Docket No.: 52-011

AR-07-0061

Southern Nuclear Operating Company
Vogtle Early Site Permit Application
Response to Requests for Additional Information on the Environmental Report

Figure 1

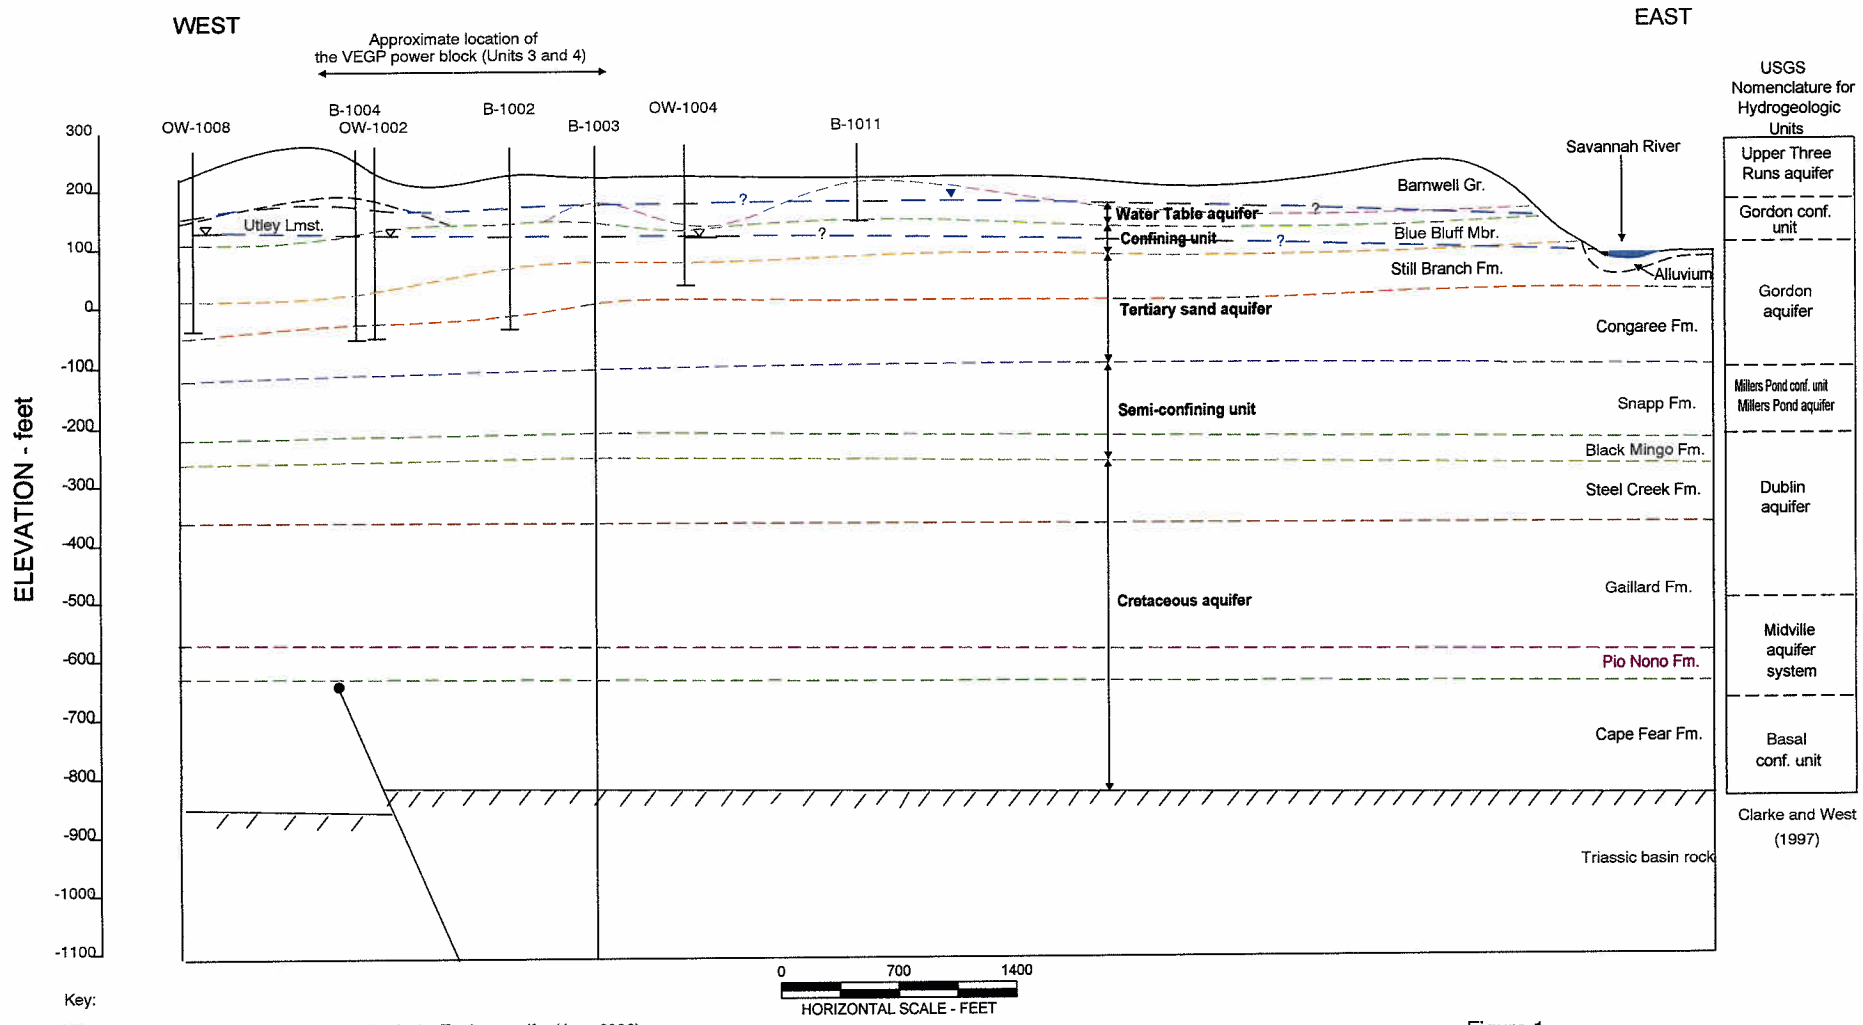
E2.3-2 **Section 2.3.1.2 Groundwater Resources, Section 2.3.1.2.2 Local Hydrogeology, Section 2.3.1 -2.4 Hydrogeologic Properties Describe the process used to develop the site hydrogeologic conceptual model so that the staff can understand (a) drawdown at offsite wells, (b) impacts to and loss of wetlands, and (c) alteration of groundwater gradients and degradation of water quality from their current state. Provide a thorough description and discussion of the conceptual model(s), and how the applicant's model contrasts with the conceptual models of the VEGP Updated Final Safety Analysis Report and U.S. Geological Survey studies (Clarke and West 1997, 1996; Cherry 1996). Provide complete references and describe the datasets that the site conceptual model relies upon for calculating: (1) the water budget (e.g., precipitation, runoff, pumping); (2) monitoring of well water levels during construction of VEGP Units 1 and 2; (3) tritium observed in the unconfined aquifer; (4) tritium observed in the confined aquifers; (5) trans-river flow; (6) changes in the near-field subsurface conceptual model due to changes in recharge, .fill material, and ernbedded structures; (7) continuity of the Utley Limestone; (8) continuity of the Blue Bluff Marl with respect to data from wells OW-1 001/1001A (screened at water table aquifer elevation, but with measured hydraulic head values more consistent with the Tertiary aquifer); and (9) evidence indicating that the Tertiary and Cretaceous aquifers are highly isolated in light of the potential for the Pen Branch Fault to offset the hydrologic units. This description and discussion of the conceptual model should discuss hydraulic connection of the hydrologic units to the Savannah River through river alluvium, and the location and role (e.g., conduit or barrier for transport) of the Pen Branch fault.**

Schematic diagram showing hydrogeologic units at the Vogtle Electric Generating Plant (VEGP) Site (Units 3 and 4) drawn from the power block area to the new intake structure (See SSAR Figures 2.4.12-3 and 2.5.4-1)

FIGURE 1.0 PLAN-RIVERFRONT STRUCTURES

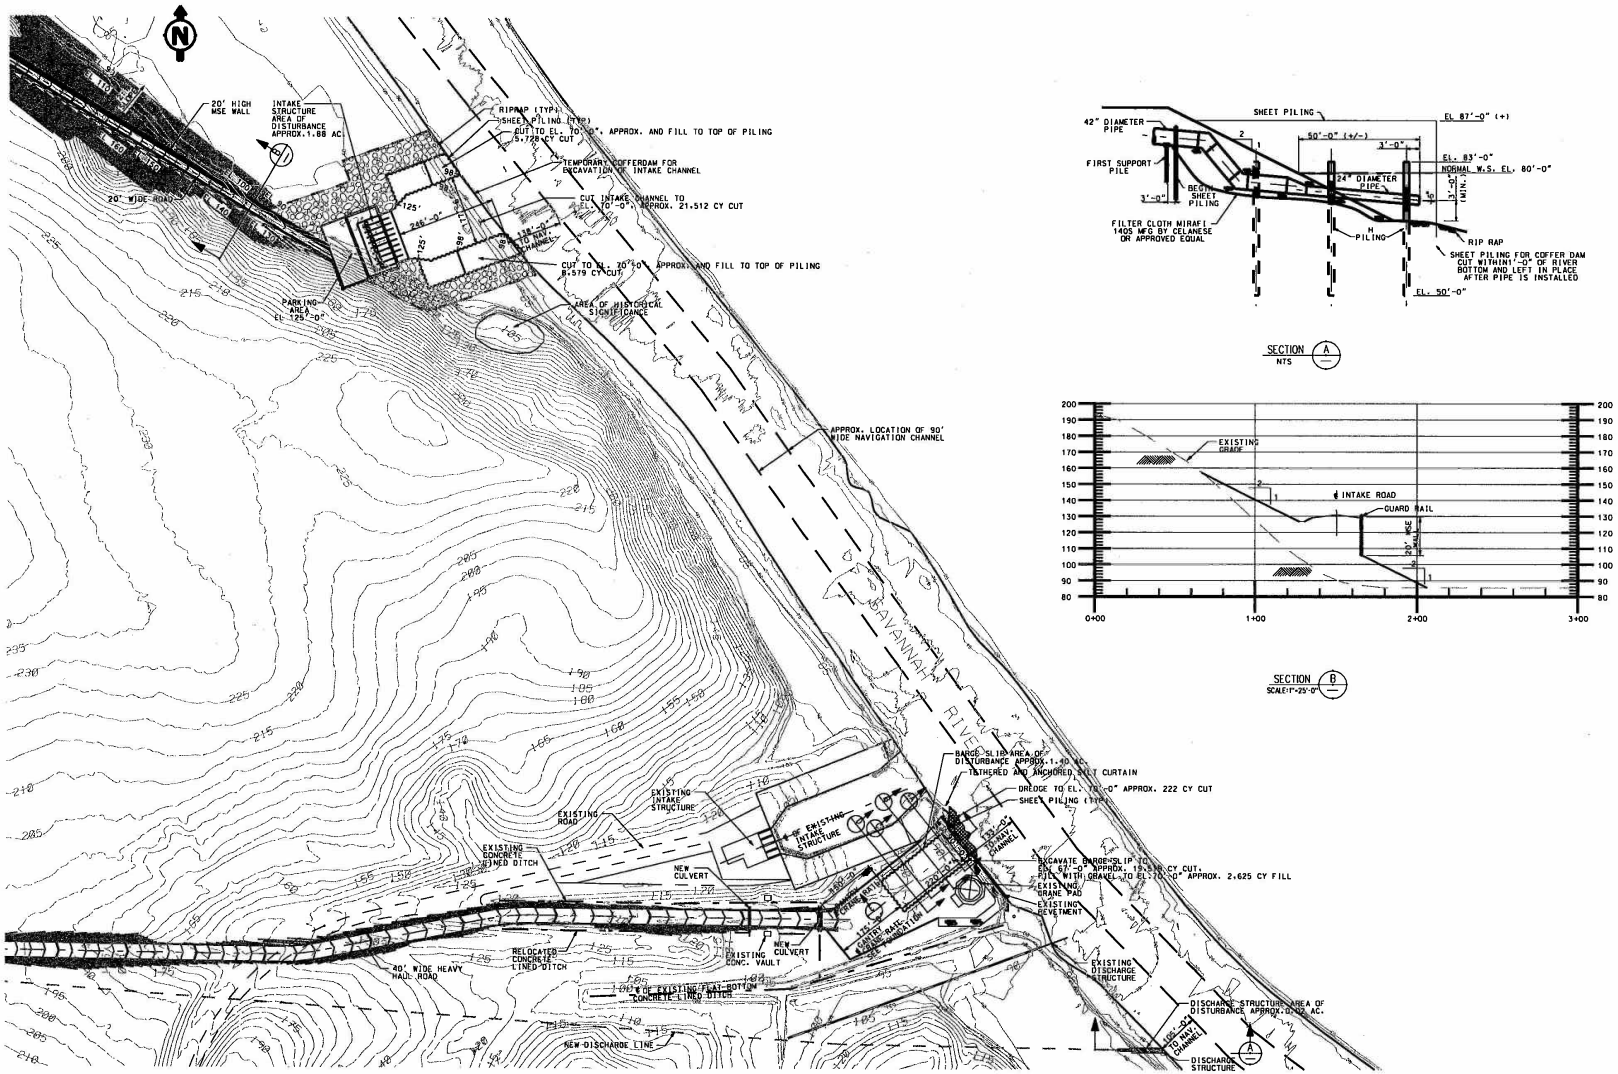
E3.9-5 **<u>Section 3.9.2.9 Docking and Unloading Facilities Installation</u>, The ER states that "The existing barge slip must be enlarged to support unloading the AP1000 components and modules. The downstream sheet pile wall must be removed and the slip must be excavated to the correct dimensions. The downstream sheet pile wall will be reconstructed and the shore line stabilized prior to use." Provide a map of the site and vicinity delineating the areas of construction and indicate where the actual structure would be located. Provide the proposed construction activity schedule. Provide plan and section views of the new/expanded barge slip, If dredging is involved, identify the areal extent of dredging, the depth of dredging, and the volume of dredged material. Describe any fill material and the volume of material to be placed below the ordinary high water (OHW) level line.**

E3.9-7 **<u>Section 3.9.2.10 - Intake/Discharge Coffer Dams and Piling Installation</u> In addition to the information provided on Figures 3.4-2 and 3.4-4 for the new intake and discharge structures, provide the following information: 1) Distance from intake structure and discharge structure to Federal navigation channel; 2) Dimensions of all fill to be used in the Savannah River (including backfill and temporary fill for structures such as cofferdams and access roads); 3) Describe fill materials and number of cubic yards to be placed below the OHW level line; and 4) If dredged material is involved, show the extent of dredging, describe the type of material, number of cubic yards, and method of handling.**

E3.9 Figure 1 provides a detailed plan the proposed location of the new Barge Slip to support construction of Units 3 and 4. The slip is located southeast of the existing River Intake Structure for Units 1 and 2, and northwest of the existing Barge Unloading Facility. The proposed construction activity schedule for the new Barge Slip would begin upon the issuance of the Early Site Permit (ESP), Limited Work Authorization (LWA), and other necessary permits.

Construction of the new barge slip will require approximately 300 yd^3 (the quantity could be different at the time of construction) of soil to be dredged from the bed of the Savannah River as part of the formation of the east end (river interface) barge slip envelope. The depth of the dredging is to approximately Elevation 67'msl, with the boundaries of the area to be dredged shown in E3.9 Figure 1.

As shown on ER Figure 3.1-4, the estimated total area of disturbance for construction of the new Intake Structure and the new Barge Slip/Discharge Structure is approximately 12.5 acres and 10.3 acres, respectively. Refer to E3.9 Figure 1 for a breakdown of the areas of disturbance and sizes of specific portions of the structures.

As shown on E3.9 Figure 1, the sloped areas adjoining the Intake Structure will be covered with rip rap for protection during high water.

The navigation channel is 90' wide and shown on E3.9 Figure 1. The minimum distance from the westernmost edge of the navigation channel is approximately 138'for the Intake Structure and approximately 105' for the Discharge Structure.

Refer to E3.9 Figure 1 for the boundaries of the dredging from the riverbed In support of construction of the Intake Structure and the Discharge Structure.

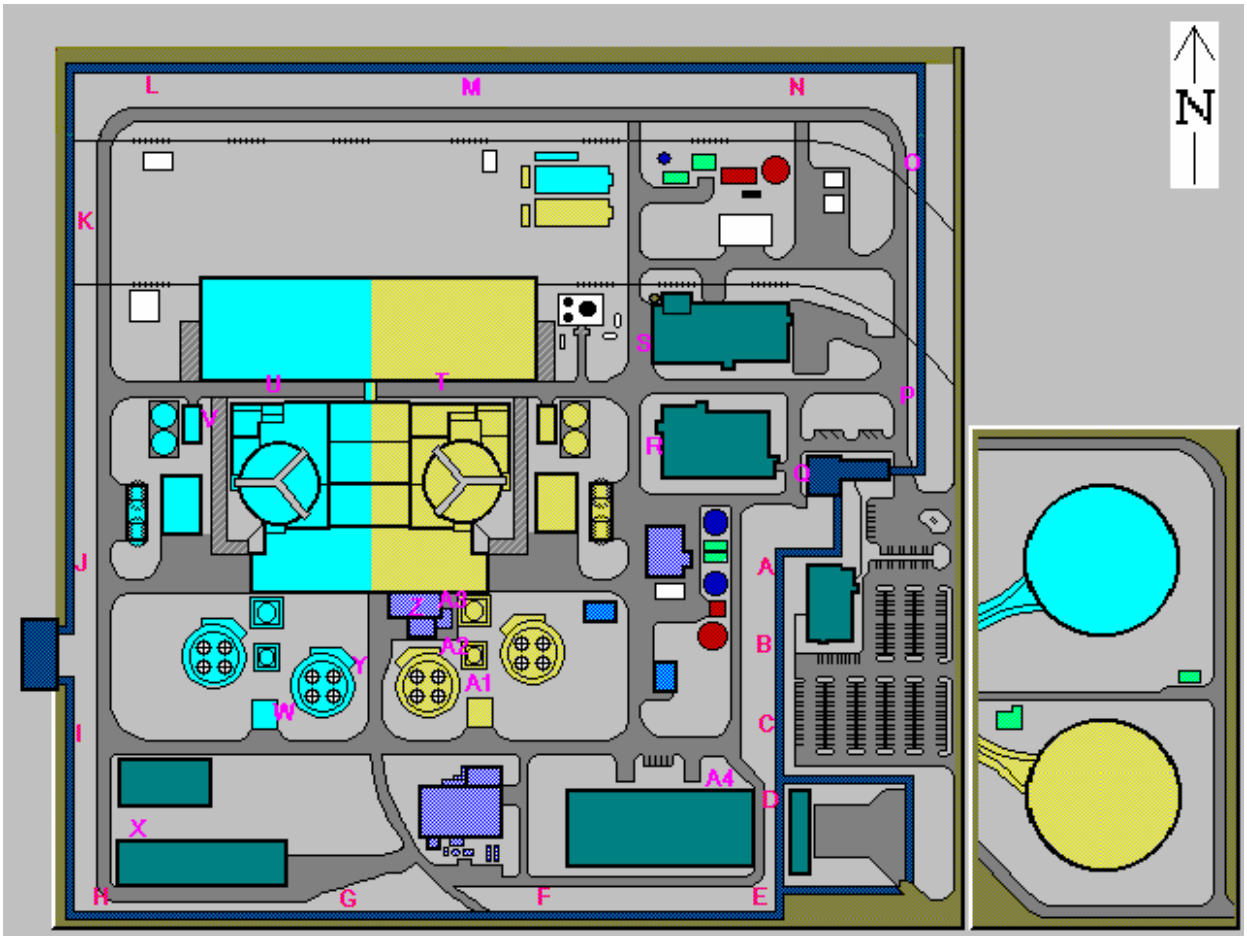
E4.5-1 **<u>Section 4.5 Radiation Exposure to Construction Workers</u> Provide a site map indicating the location of the internal and general area TLD's used to estimate the annual direct radiation dose to the construction workforce of 50 mrem which is listed in Section 4.5.3.1 of the ER.**

Following is a site map indicating the location of the TLD's used to determine the dose estimate at the Protected Area Fence closest to the construction site at VEGP Units 1 & 2. The TLD's used to determine this dose estimate are at Stations G, H, I, J, K and L.
